W3F1-2004-0017

SUBJECT: Supplement to Amendment Request NPF-38-249
Extended Power Uprate
Waterford Steam Electric Station, Unit 3
Docket No. 50-382
License No. NPF-38

**Response to Request for Additional Information
Meteorological Data and Atmospheric Dispersion Calculations**

**Response to Request for Additional Information
Steam Generator Integrity and Chemical Engineering**

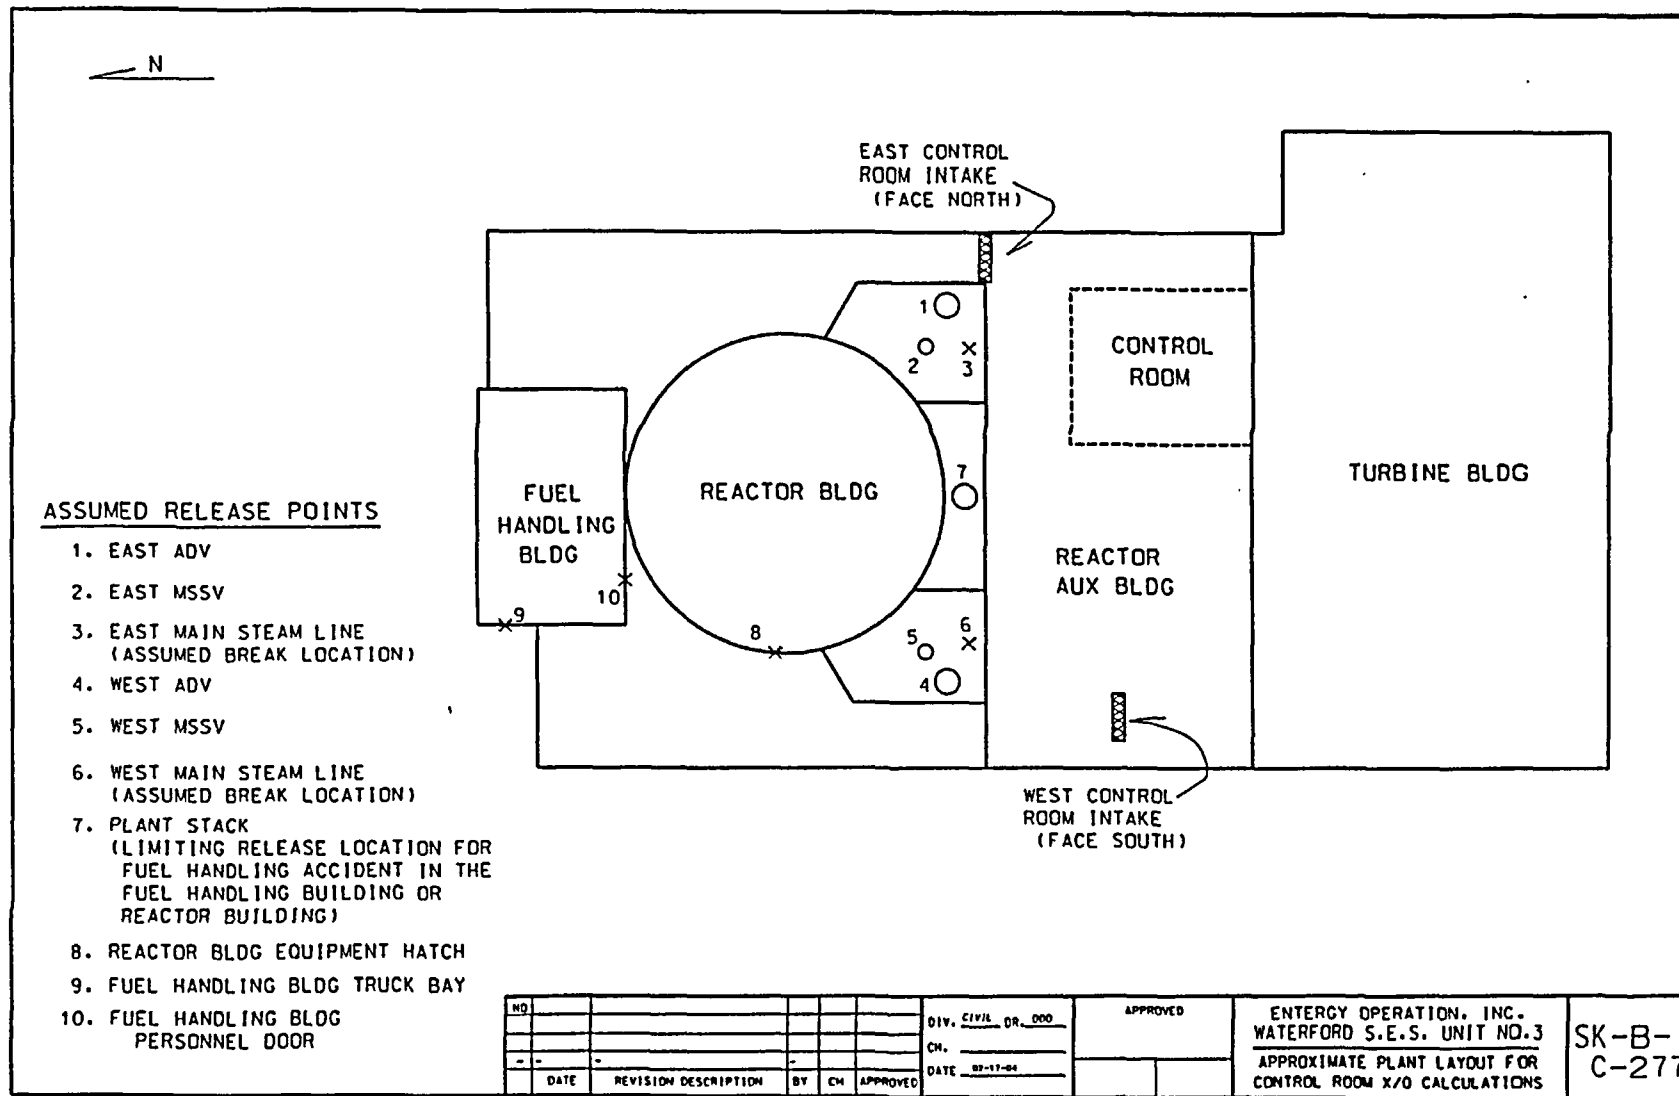
For control room X/Q calculations, please provide a figure or figures showing the assumed locations of release and control room intakes with respect to the overall plant layout. Provide a quantitative list of all inputs used in estimating the postulated transport of effluents from each of the release locations to the intakes. A copy of the ARCON96 printouts is acceptable to show inputs. Was the physical height of the release location assumed or was an effective release height used in any calculation? If flow rates were assumed when making X/Q calculations, were they based on technical specification (TS) values? If more than one release to the environment or more than one transport scenario could occur (e.g., loss-of-offsite power and non-loss of site power, single failure), were comparative XQ calculations made to ensure consideration of the limiting dose?

X/Q values have been calculated for two intakes. Were the X/Q values used in the dose assessment based upon the more limiting release and intake pair, upon a weighted average (e.g., as described in RG 1.194, "Atmospheric Relative Concentrations for Control Room Radiological Habitability Assessments at Nuclear Power Plants,") or some other criteria? If weighted values were used, describe how estimates were calculated, including inflow rates of each intake and any reduction factors (e.g., due to automatic selection of the least

contaminated outside air intake). Provide justification for the use of any reduction factors. If applicable, are control room air intake inflow rates based upon measured values? Confirm that each of the control room intakes meet applicable design criteria of an engineered safeguards feature, including single-failure criterion, missile protection, seismic criteria, and operability TS to merit reduction credit as dual intakes.

See diagram at the end of Attachment 1 for the approximate locations of the assumed release points and approximate locations of the control room intakes. The intervening structures between the release point and the control room intakes were ignored for calculational simplicity, thereby underestimating the true distance to the control room intakes.

Note that Section 3.4 of RG 1.194 states that, "If the distance to receptor is less than about 10 meters, the ARCON96 code and the procedures in Regulatory Position 4 should not be used to assess X/Q values. These situations will need to be addressed on a case-by-case basis." RG 1.194, however, does not provide alternative method for calculation of the X/Q values for these conditions. There is one release location at Waterford 3 (East atmospheric dump valve (ADV) to East Control Room (CR) intake, distance = 6.6 meters) that does not meet this guidance. The X/Q result for this location was compared with a location in a similar direction with a distance close to 10 meters. The comparisons indicated that the X/Q values for this location are reasonable for use in the dose calculation.

The X/Qs were calculated for all possible release points (e.g., east and west side ADVs and main steam safety valves (MSSVs)) to both control room emergency air intakes.

Comparison of Thickness Predictions

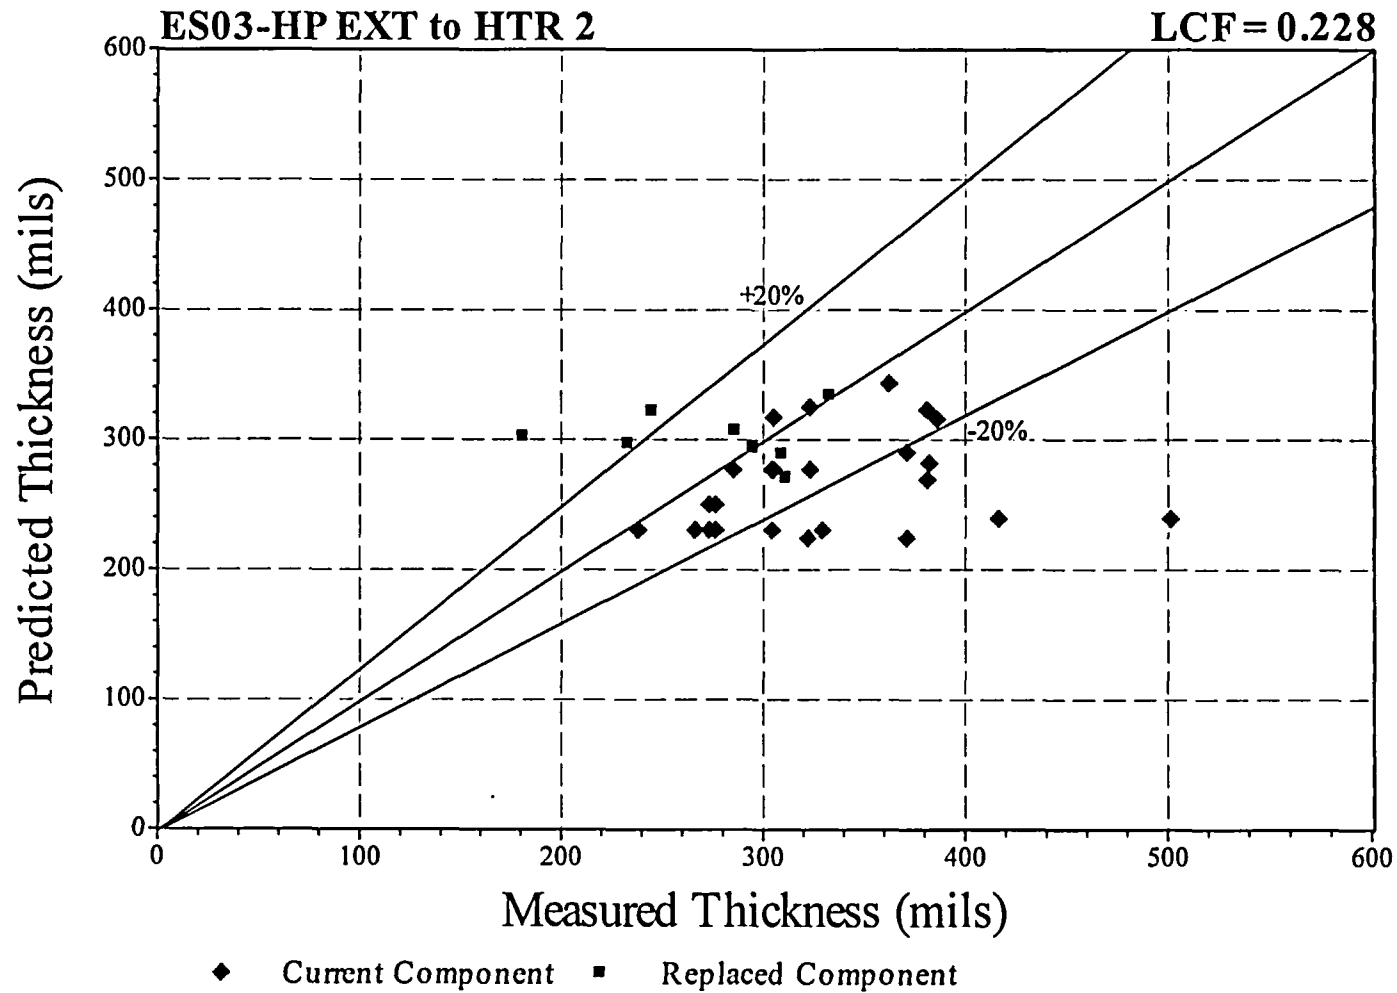
The pipe wall thinning caused by FAC is predicted by the Electric Power Research Institute's CHECWORKS computer code. In order to allow the staff to evaluate the accuracy of these predictions, please provide examples of the piping components for which wall thinning is predicted by the code based on the current operating conditions and at the same time measured by ultrasonic testing or any other method employed in Waterford 3. This procedure (predicted wall thickness vs. measured wall thickness comparison) will show the effectiveness of CHECWORKS in predicting the as-found condition.

The data in the Waterford 3 FAC Program Pre / Post Power Uprate Wear Rate Summary (see below) shows the predicted vs. measured data on the piping. Additionally, the CHECWORKS "Comparison of Thickness Predictions" scatter plot (see below) gives a visual representation of the measured vs. predicted thickness for the CHECWORKS run ES03. The plot compares the predicted thickness (as adjusted by the line correction factor) with the measured thickness along the +/- 20% boundary lines and shows that CHECWORKS conservatively predicts the wear.
